### **Twizel Youth Centre Condition Assessment**

Further to your email request 7 December 2020, and Beca's proposal dated 11<sup>th</sup> December 2020 we have undertaken a visual assessment of the Twizel Youth Centre 14<sup>th</sup> December 2020. The site assessment was undertaken to verify identified building issues in Grant Hyde's DRAFT Twizel Youth Centre Survey dated 25/09/2020.

Photo 5. Subfloor

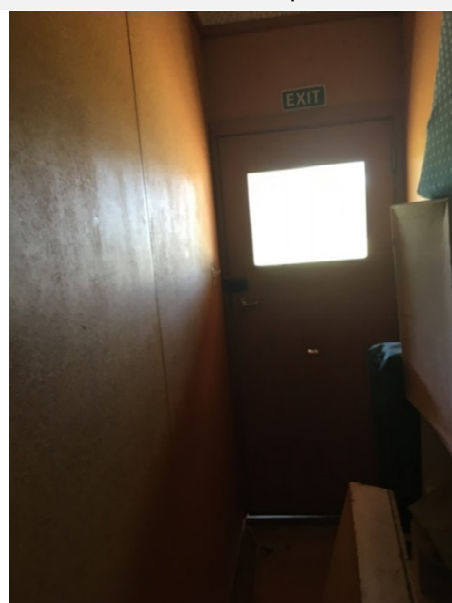
Generally, exposed timber verandah beams are rotting and the verandah posts are starting to show signs of decay (photos 2, 3 & 4). The subfloor space appeared to be dry and well ventilated (photo 5). The interior building framing was not visible without invasive inspection.

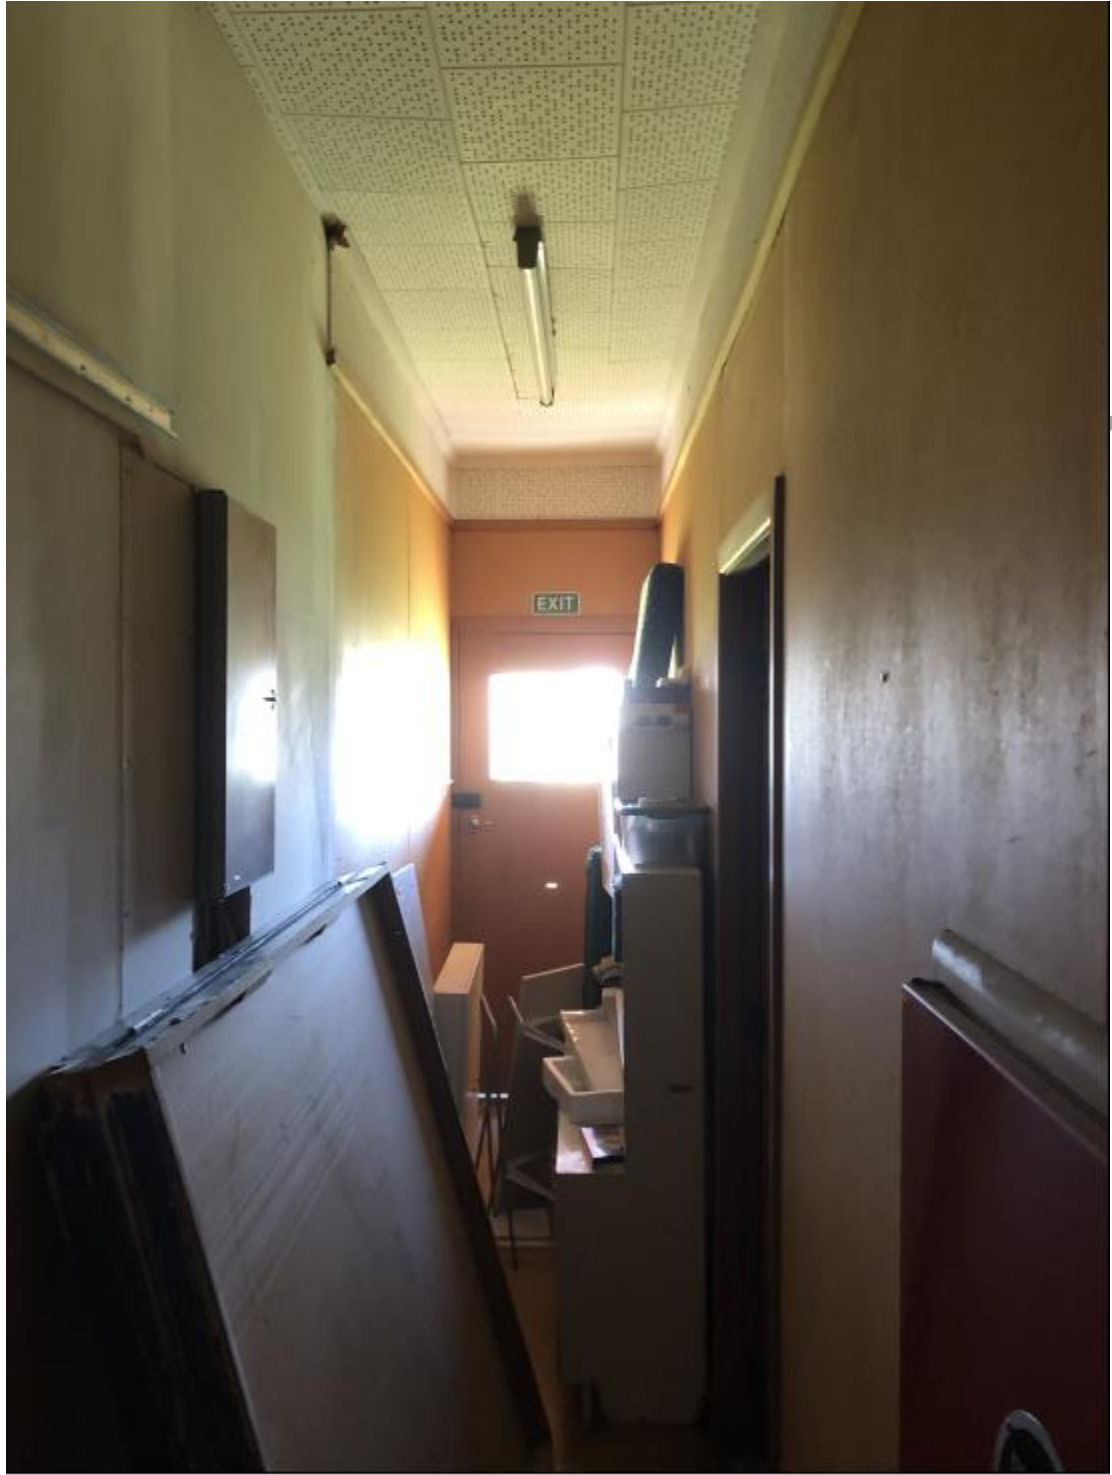
3. A manual call point alarm is located beside the kitchen area which looks to be un-serviced.
4. Sanitary facilities seem to be working apart from the showers which where currently used as a storage area.
5. Some electrical fittings/switches are in need of replacement or repair with duct tape used (see photos).
6. The HWC requires restraints with flooring removed underneath for repairs.
